Operator: BONANZA CREEK ENERGY OPERATING COMPANY LLC

Location Name: Antelope D-18

Inspection: 696305541

Exhibit E

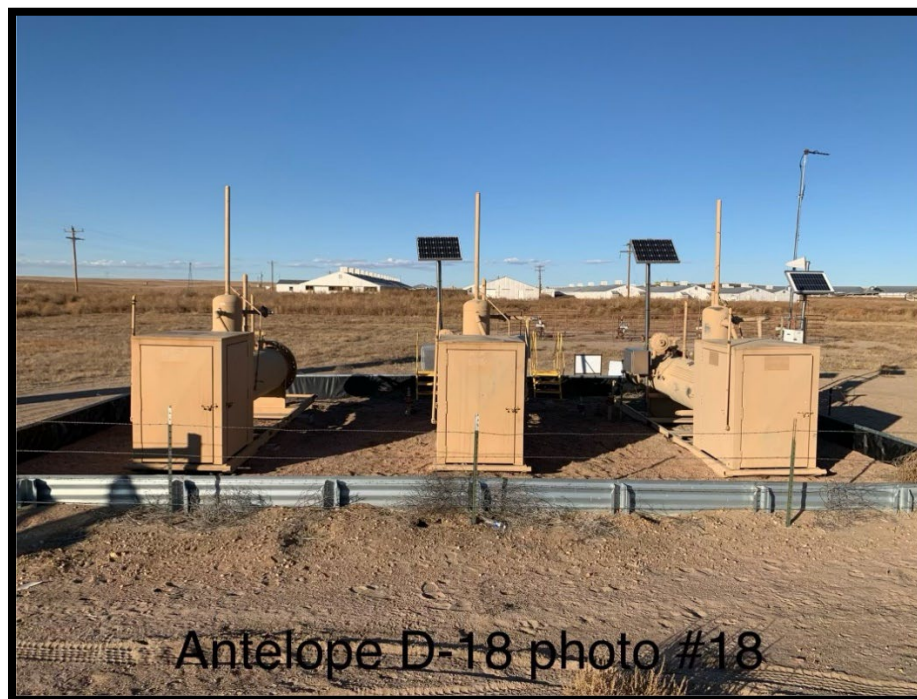
CA: Northeast Crude Oil Tank - Content and Capacity Labels have faded no longer visible. See photos Install sign to comply with Rule 605.h.

CA: Tumbleweed Debris at Separators. See Comply with Rule 606

CA: Unused Pipe, Fitting, Parts and Heat Stacks at Tanks and Separators. See photos Comply with Rule 606.

CA: All 3 Separators are open to Atmosphere. All Open-ended openings shall be covered at Pipe, Valves and where Heater Stacks were removed. Install or repair wildlife protection equipment. Prevent any unauthorized discharge (specify condition if it is E&P waste, improper disposal, trash, etc.) Per Rule 902.b.

CA Resolution: Operator has appropriately added/updated labels on NE Crude Oil Tank to comply with Rule 605.h.

CA Resolution: Identified tumbleweed debris will consistently be cleared to help maintain the location and comply with Rule 606.

CA Resolution: Operator has appropriately removed identified, unused equipment from the location to comply with Rule 606.

CA Resolution: Operator has appropriately addressed the (3) Separators that are open and effectively installed coverage to prevent unauthorized discharge to comply with Rule 902.b.
